Technical Memorandum

TO: Mr. Alan Day, General Manager
Brazos Valley Groundwater Conservation District

SUBJECT: Review of James Brien Simsboro Aquifer Evaluation Report

DATE: February 6, 2023

Figure 2. Map of Wells Near the Proposed Wells

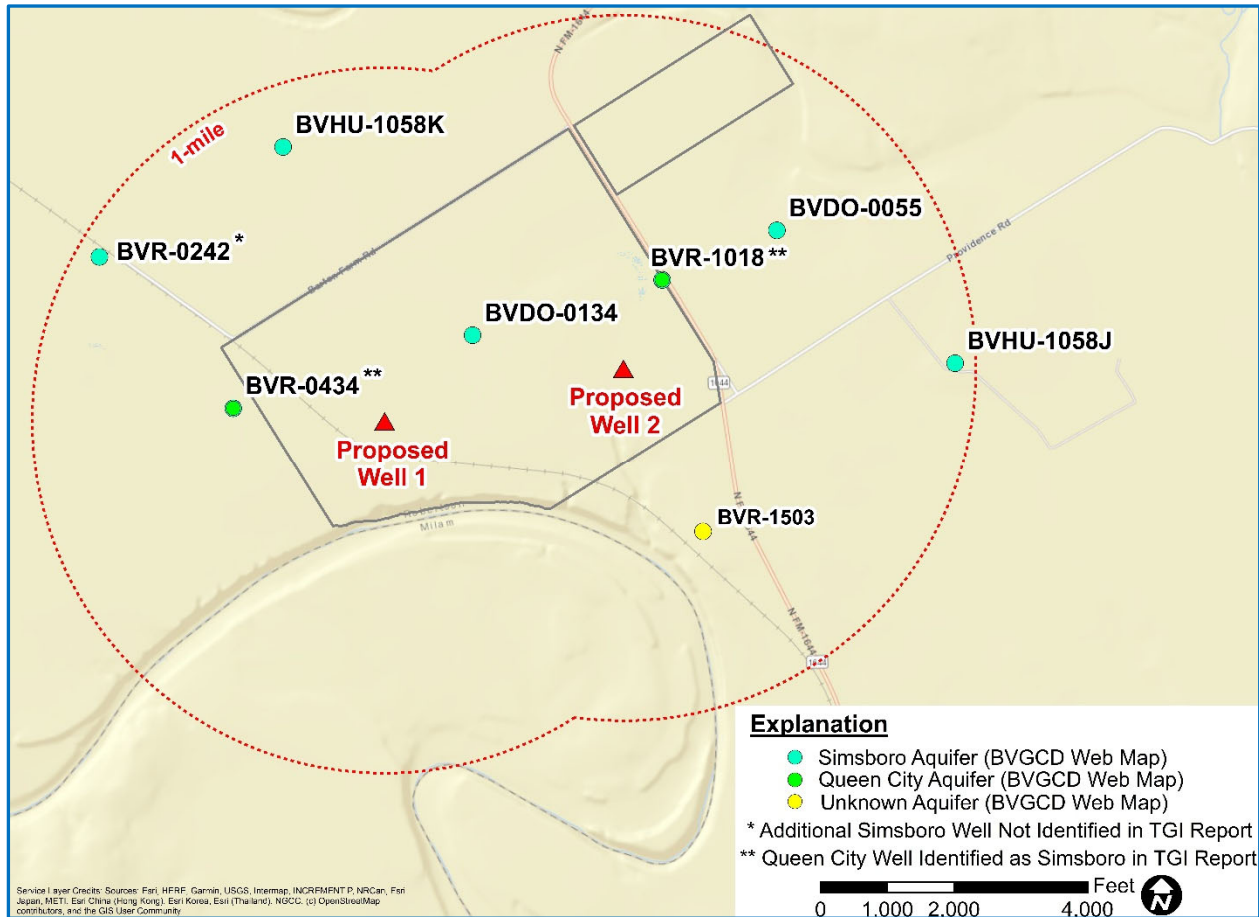
A map showing the location of the proposed wells and the BVGCD registered or permitted wells within one mile of the proposed wells is included as Figure 2 in the Aquifer Evaluation Report. We would recommend labeling each well with the permit or registration number. AGS has included a map with the wells labeled as Figure 2 below.

The six (6) permitted or registered wells identified within one mile of the proposed wells were compared to wells shown on the BVGCD Groundwater Management Application Public Web Map (<https://brazosvalleygcd.half.com/default.aspx>). Table 2 from the TGI report includes two wells listed as Simsboro that are identified as Calvert Bluff on the BVGCD Web Map (BVR-0434, and BVR-1018).

BVR-0242 is identified as a Simsboro well on the BVGCD Web Map and is located within one mile of the proposed Brien 1 well location. BVR-0242 is not included in Table 2 of the TGI report or shown on Figure 2 in the Aquifer Evaluation Report. The BVR-0242 State of Texas Well Report (Tracking Number 495742) shows the well screened interval as 587 to 607 feet below ground level (-302 to -322 feet rsl), which would indicate that the well is completed in the Simsboro. BVR-0242 is subsequently not included in the model simulation discussion or results.

Figure 3. Projected DFC Water Level Decline at the two proposed wells.

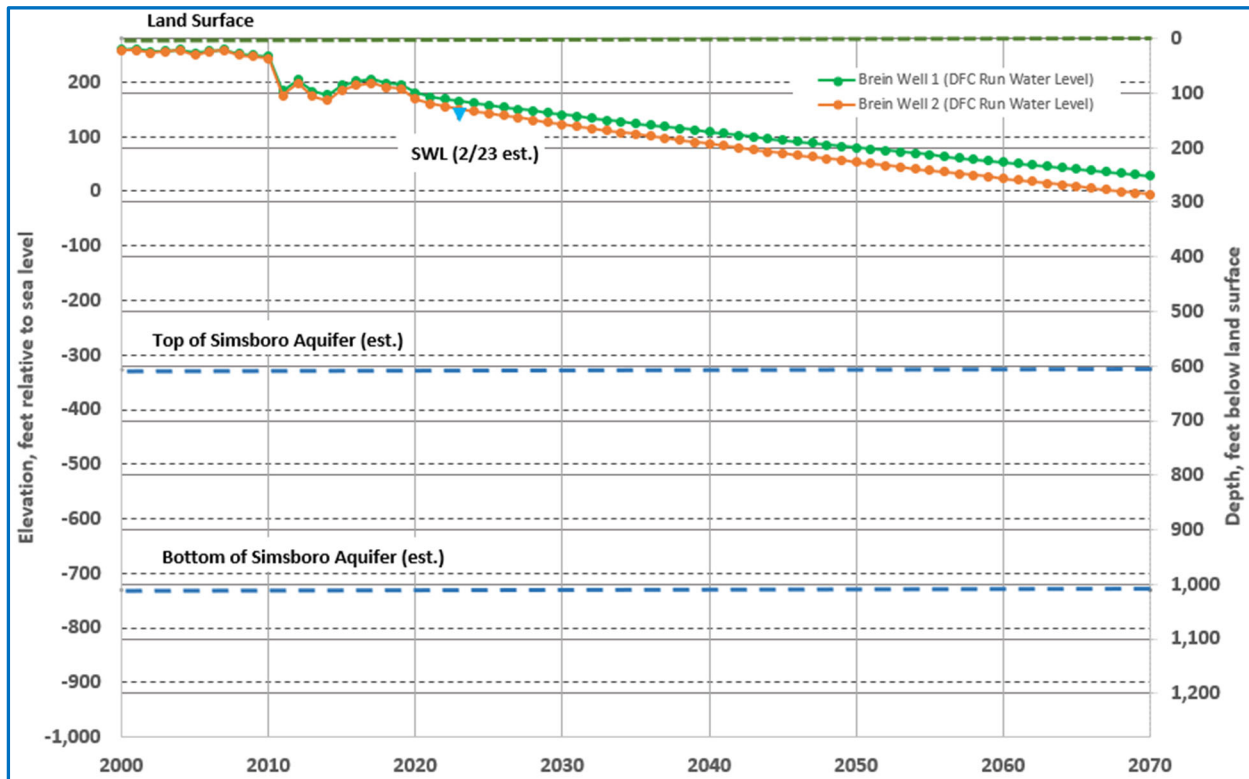
The graph illustrates the relationship between the land surface, estimated static water level through time, and the estimated top and bottom of the Simsboro Aquifer at the location of the two proposed wells. Available drawdown in wells in the Simsboro will decline over time based on the DFC simulation. Pumping water levels in wells in areas of concentrated pumping could be one hundred or more feet deeper than the estimated static water levels shown on Figure 3. Although not discussed in detail herein, these levels of water level decline in wells and artesian head decline in the aquifer will have some impact on vertical leakage, intercepted discharge, reduction in confined and unconfined storage, and potential flow directions in the aquifer.

Figure 7:
10-Year QCSP GAM
Drawdown Contours

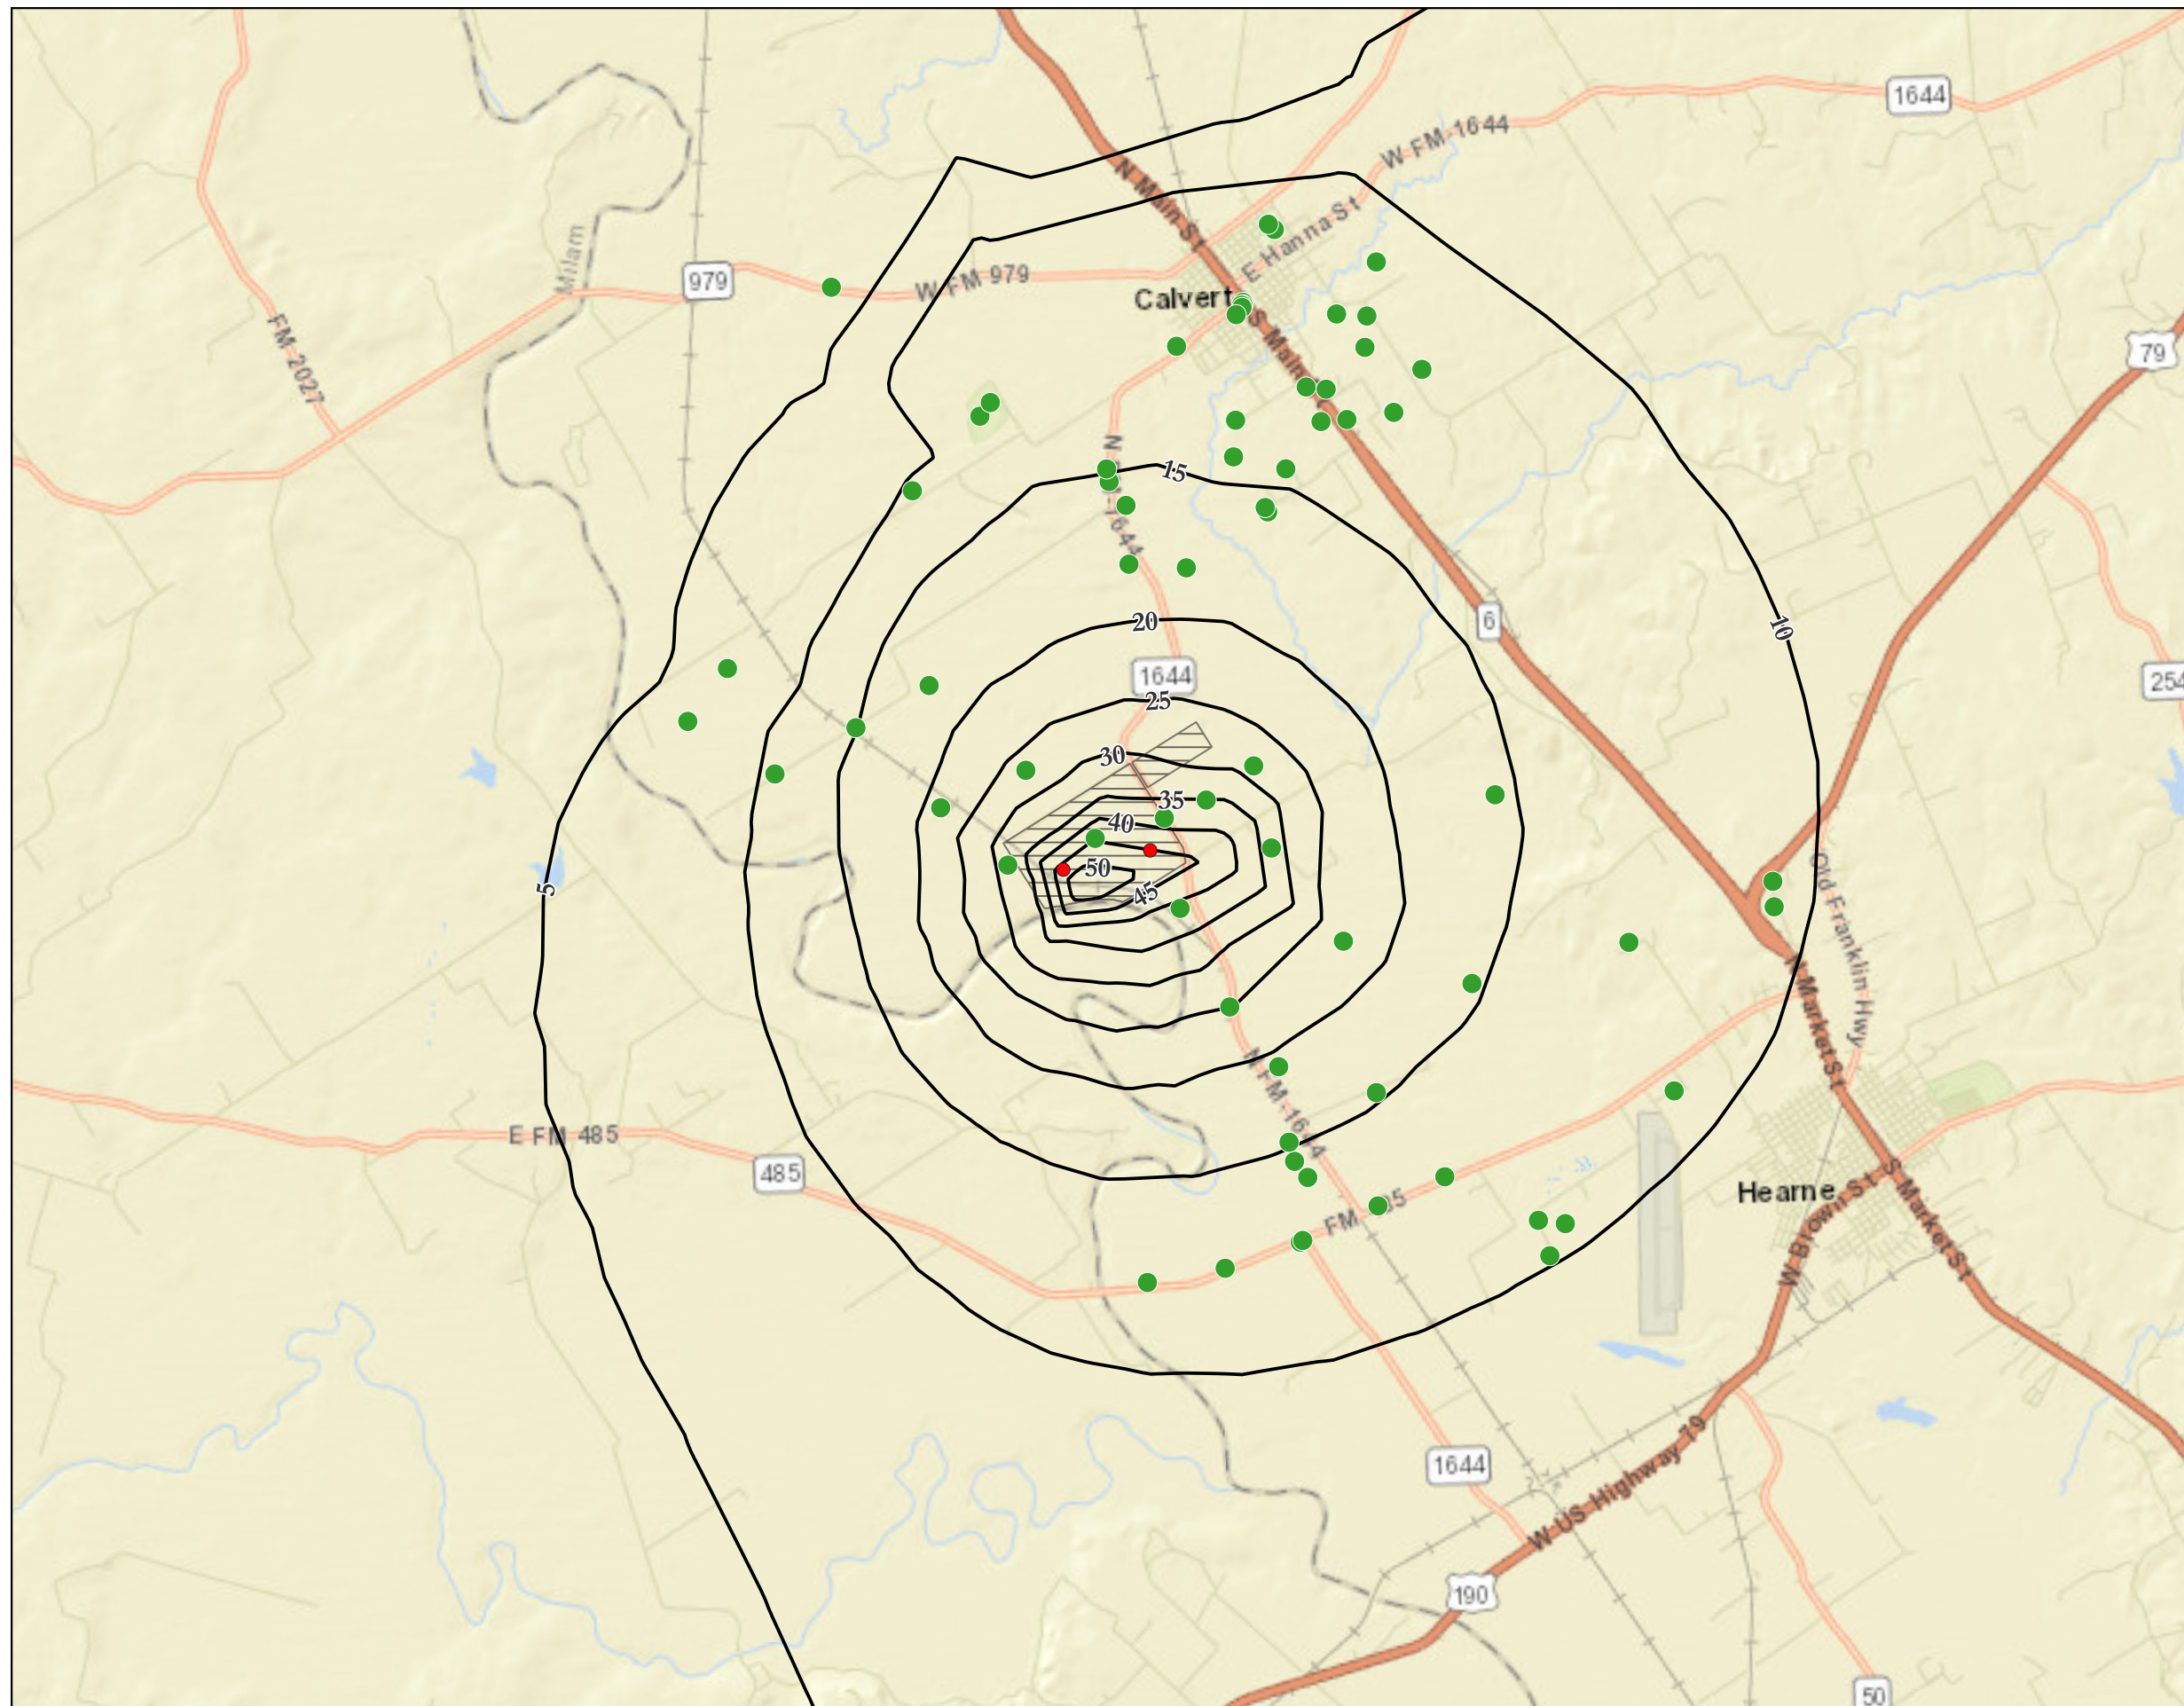
Figures 6 and 7 of the Aquifer Evaluation Report show simulated effects after one year and 10-years of pumping, respectively. The TGI 10-year GAM simulated interference drawdown is estimated to be about 20 to 50+ feet within one mile from the proposed wells and about less than five feet to 13 feet at a distance of five miles from the proposed wells, depending on the direction from the proposed wells. A copy of the TGI 10-year GAM simulated interference drawdown illustration from the Aquifer Evaluation Report (Figure 7) is attached to this memorandum. The GAM estimated drawdown contours to the northwest appear to be influenced by a fault included in the GAM, which is in the same general area as a fault that has been mapped recently by GWC and AGS.

Table 1 from the Aquifer Evaluation Report shows GAM simulated one year and 10-year drawdown estimates at BVGCD permitted and registered Simsboro wells within a five-mile radius of the proposed wells. The GAM simulated drawdown values shown in TGI Table 1 were spot checked against the drawdown contours shown on TGI Figures 6 and 7 of the Aquifer Evaluation Report.

The TGI report did not discuss the GAM simulation methodology, including how much pumping was placed at each model node. To check the results, AGS performed a GAM simulation using Version 3.02 of the Central Portion of the Sparta, Queen City and Carrizo-Wilcox Aquifers GAM (INTERA Incorporated and others, 2020) with each of the proposed wells pumping the requested annual permit allocation (Brien Well 1: 2,186 ac-ft/yr at Node 159438; Brien Well 2: 1,929 ac-ft/yr at Node 159940). The AGS GAM simulation results after one year and 10 years of pumping 4,115 ac-ft/yr show that drawdown estimates are about 5 to 10 feet less than what is reported in the TGI simulation. AGS reserves the right to perform additional model simulations in the future and review the results.
